Planning and Zoning Commission - Special Meeting AGENDA

Tuesday, September 21, 2021 at 4:30 PM
Ketchum City Hall
480 East Avenue North, Ketchum, ID 83340

7. ACTION - Recommendation to approve the Okada Design Review (P21-042) and Preliminary Plat (P21-041) located at 407 Bald Mountain Rd.
8. ACTION - Recommendation to approve the 780 N 1st Ave Design Review (P21- 069) and Preliminary Plat (P21-0368).
9. ACTION - Recommendation to hold a public hearing, consider, and take action on an amendment to the project plans approved by the Planning and Zoning Commission through Design Review Permit P20-031 proposing the addition of hot tubs within east and west side yard setback areas of the Waddell-Roush Duplex located at 3020 Warm Springs Road within the City's General Residential Low Density (GR-L) Zoning District.
10. ACTION ITEM: Recommendation to review and provide direction on requested modification to Design Review Permit P19-038, First and Fourth Street Mixed Use Project

2 EXTERIOR BUILDING ELEVATION-EAST
 A3.1 SCALE: 3/16" = 1'-0"

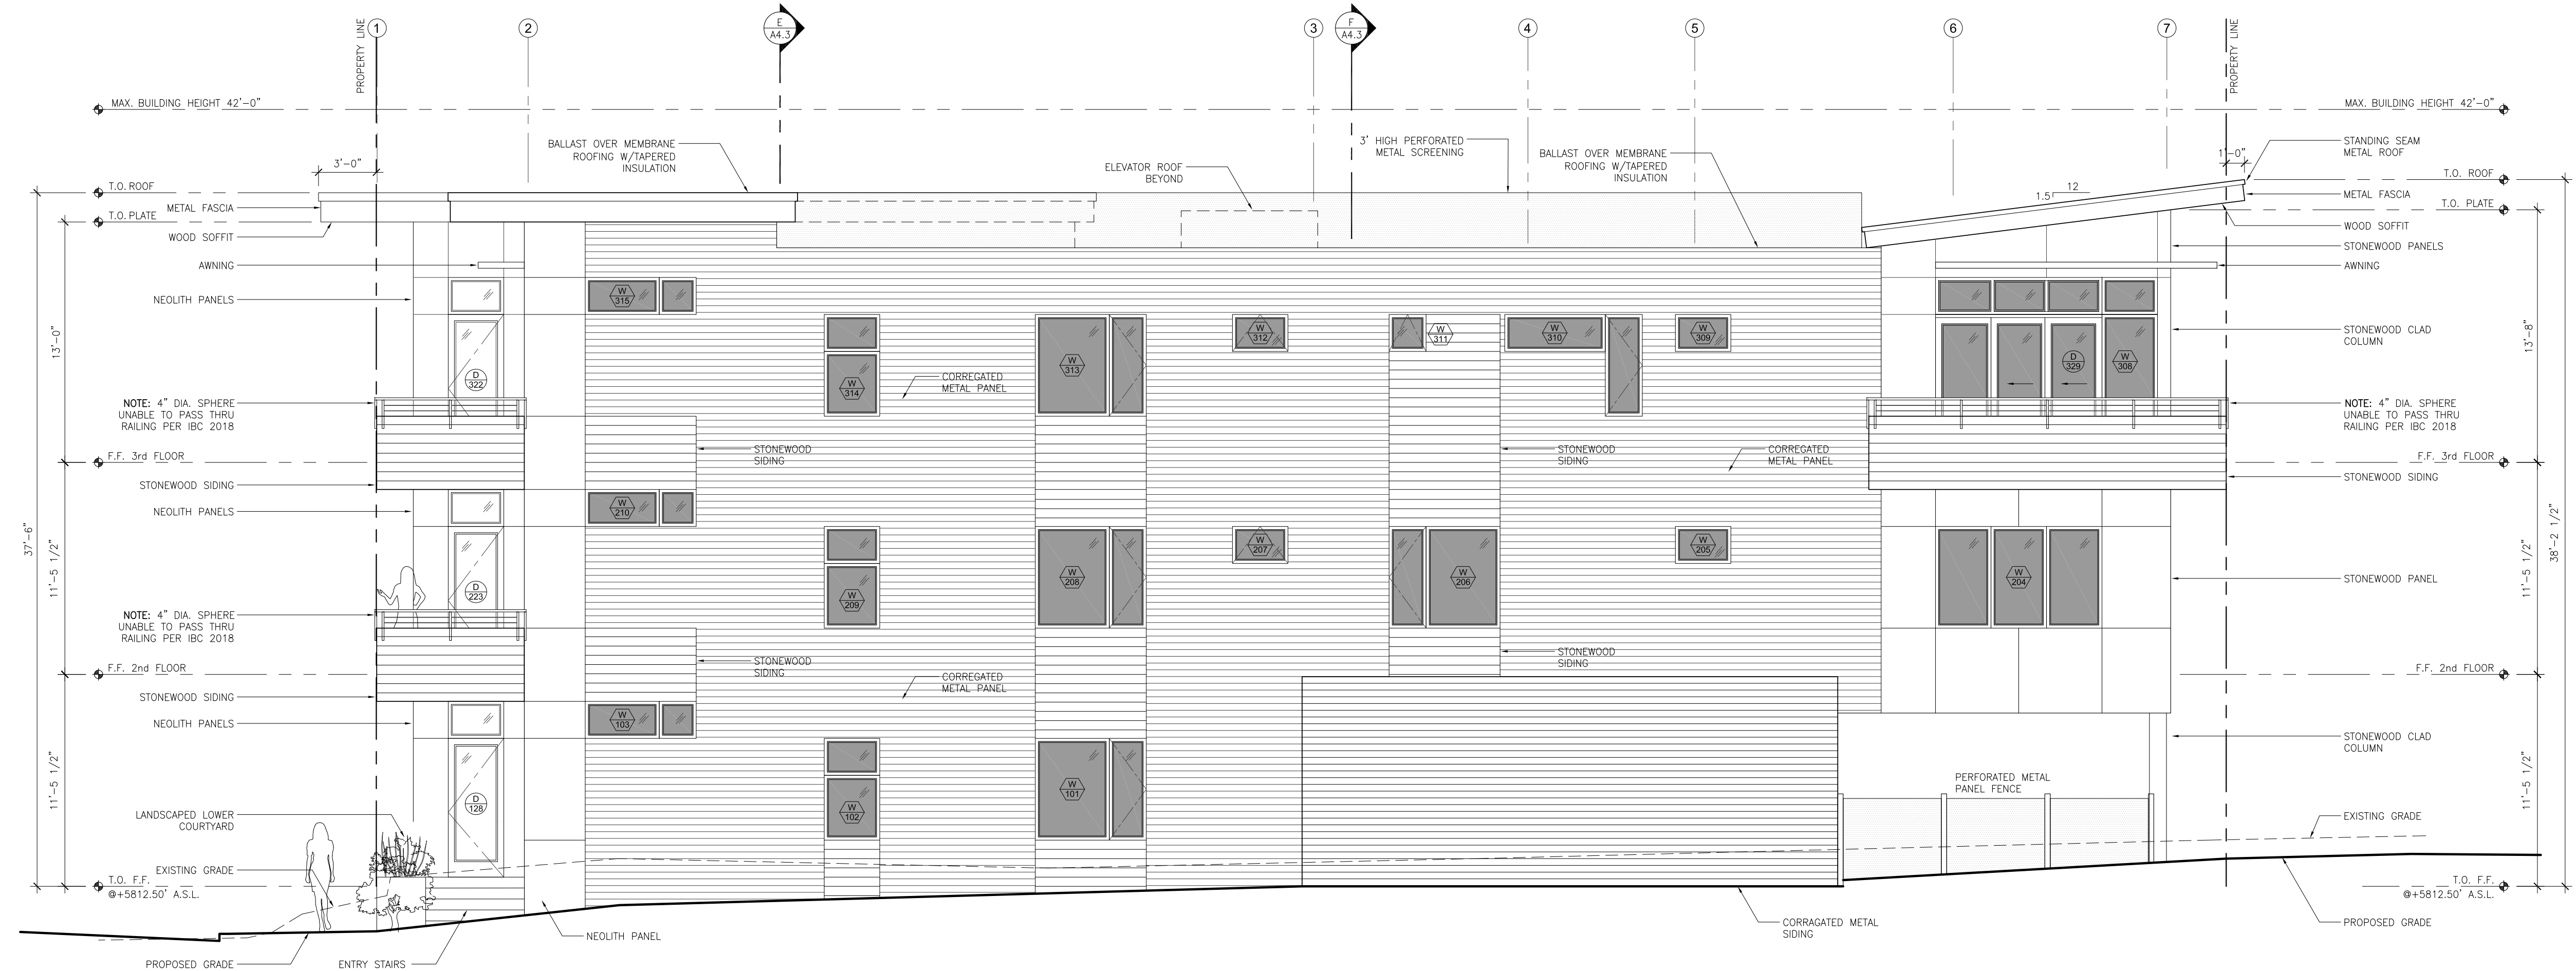
• **Screening of Rooftop Mechanical Equipment** – The sheet index for the plan set indicates inclusion of Sheet M1.3 – Roof HVAC Plan, however, the sheet is not included in the physical or electronic copies of the submittal. Sheets A3.1 and A3.2 indicate the location of the elevator roof; however, identification of materials is not included. Please clarify the intended screening, either materials or paint colors, for any rooftop mechanical equipment required for the building.

Refer to attached Building elevation A3.1, A 3,2 and Roof plan showing the location of the 3' high perforated metal screening (Bronze). See image of perforated Screen below.

1 ELECTRICAL SITE PLAN
 E1.0 SCALE: 1" = 5'

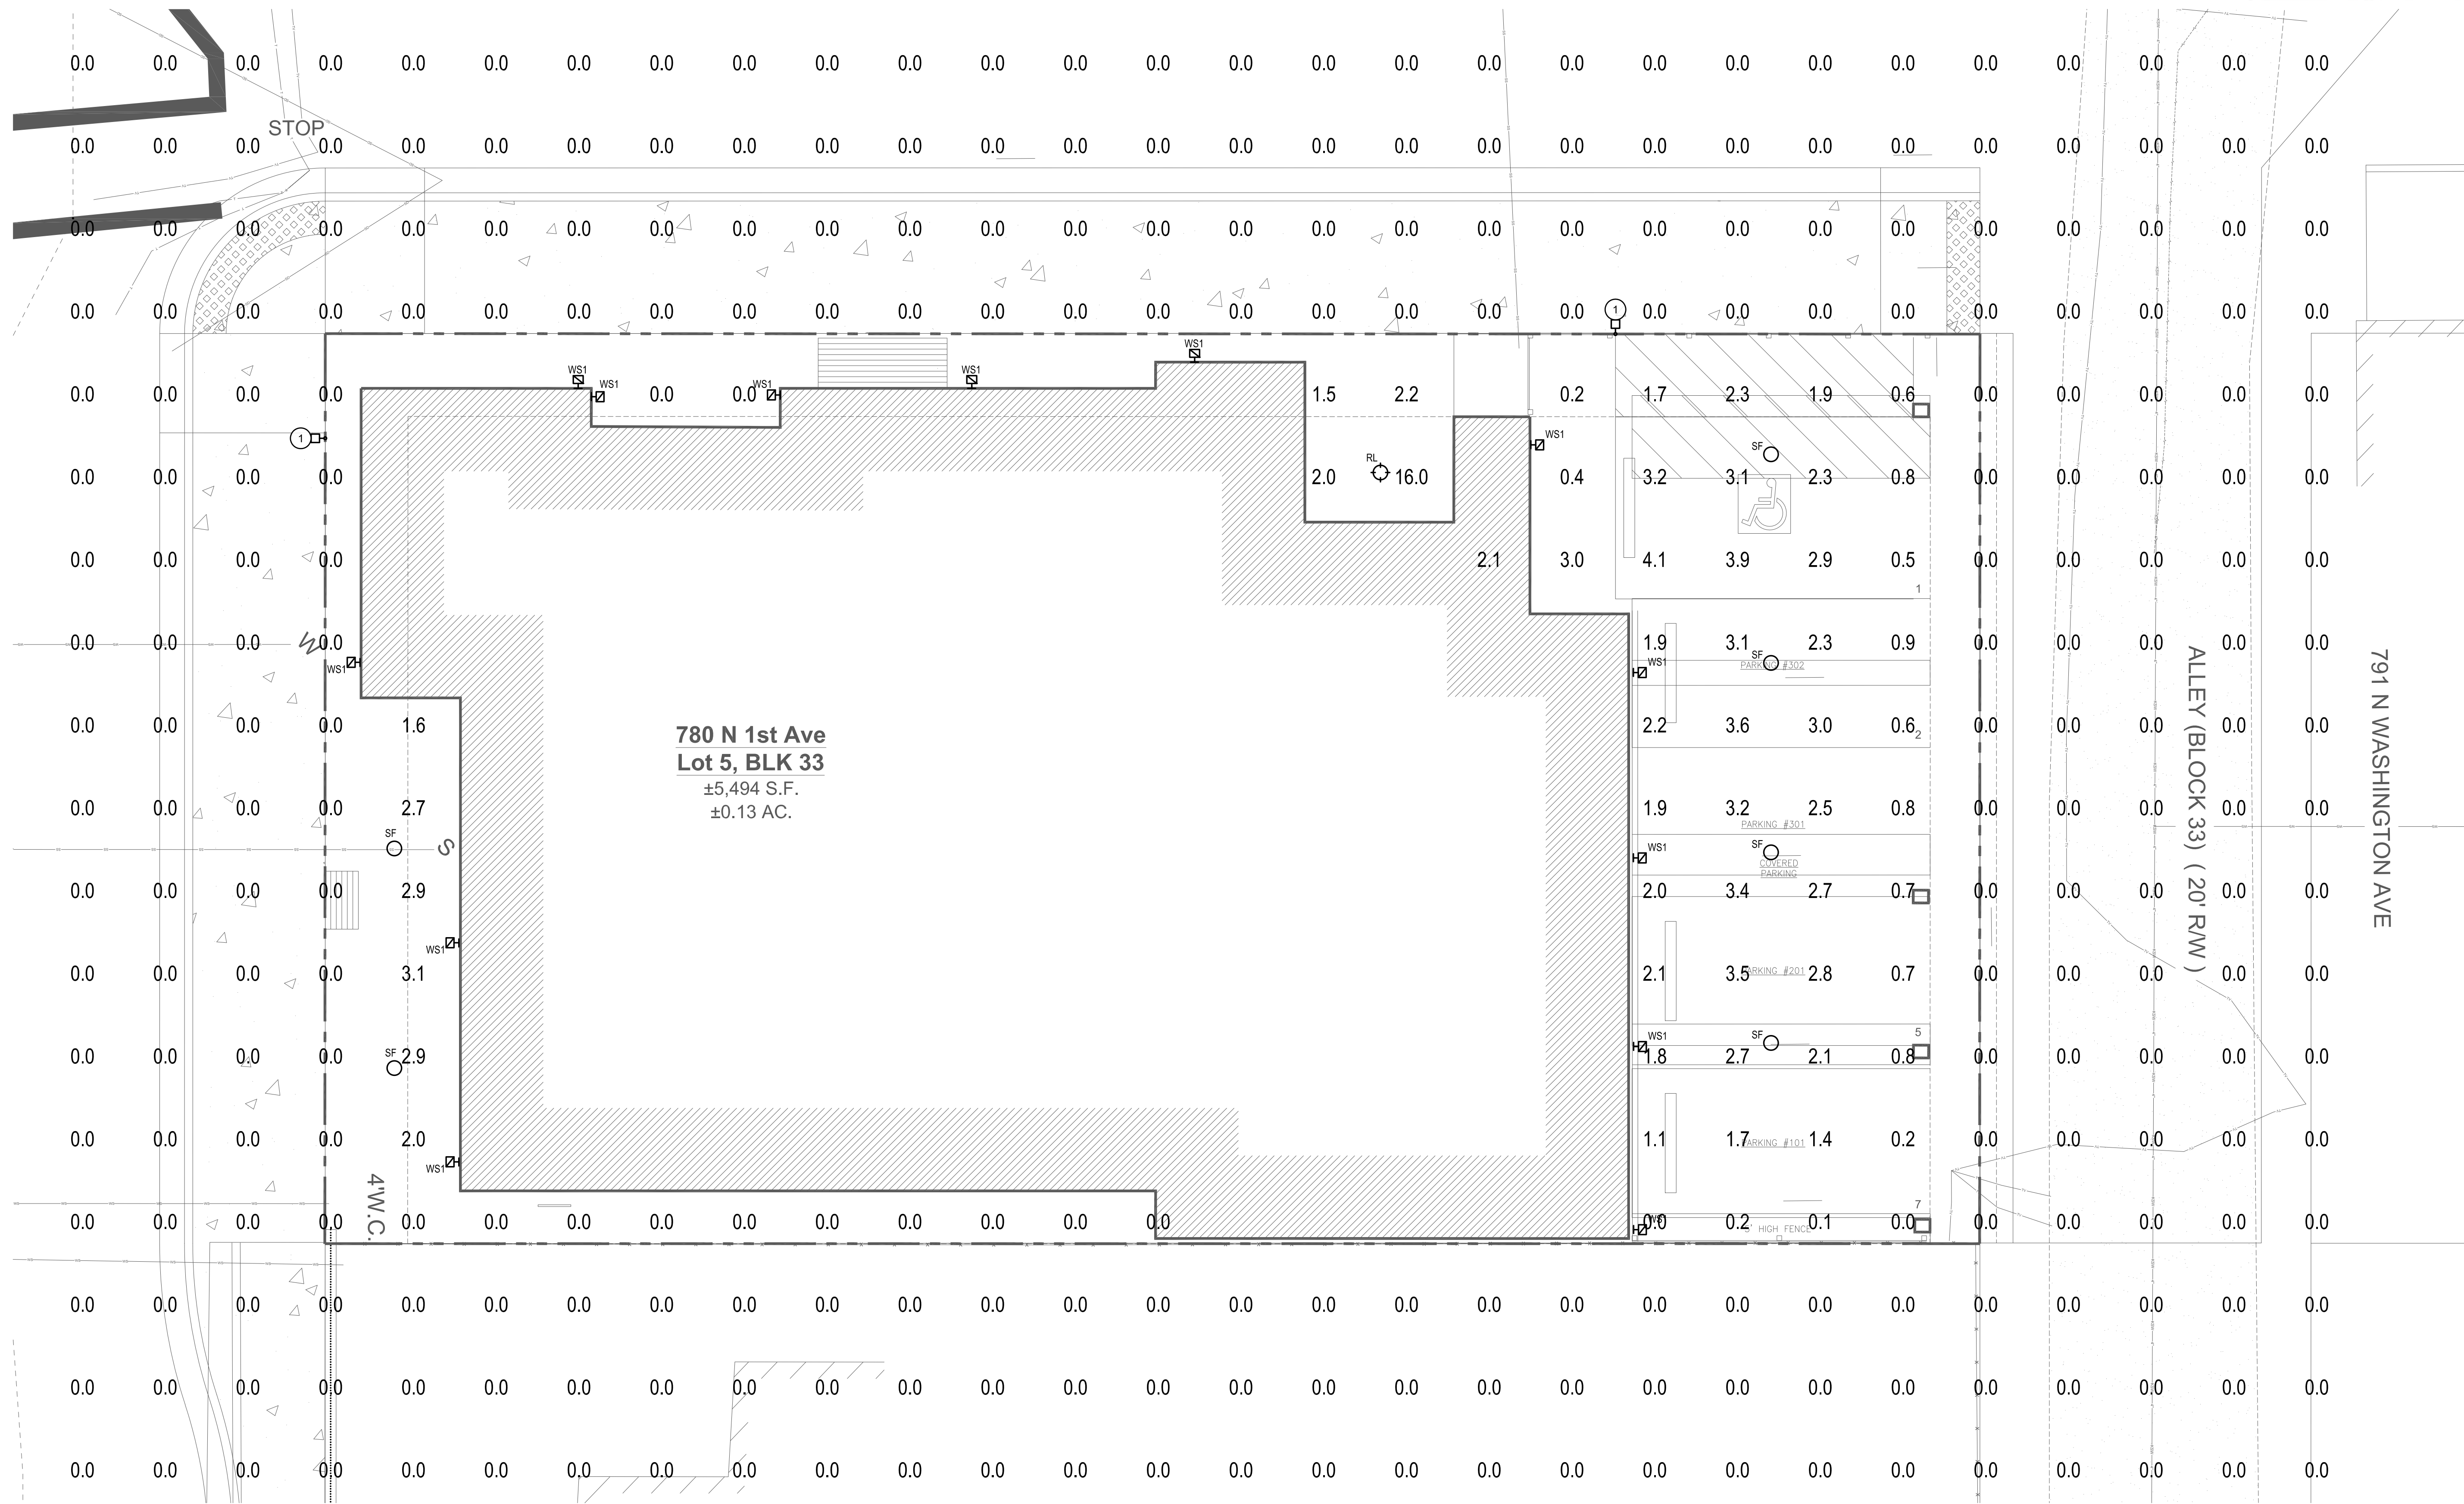
2. The junction box noted on Sheet E1.0 as note 4 is not permitted in the right-of-way. The junction box must be moved to a location within the property boundaries of the subject property. Revised electrical and civil plan sets are required for review and approval by the City Engineer prior to issuance of a building permit for the project.

3. The Century link pedestal noted on Sheet E1.0 as note 7 must be relocated or terminated as to not obstruct access to the surface and garage parking spaces for Unit #101. Revised electrical and civil plan sets are required for review and approval by the City Engineer prior to issuance of a building permit for the project.
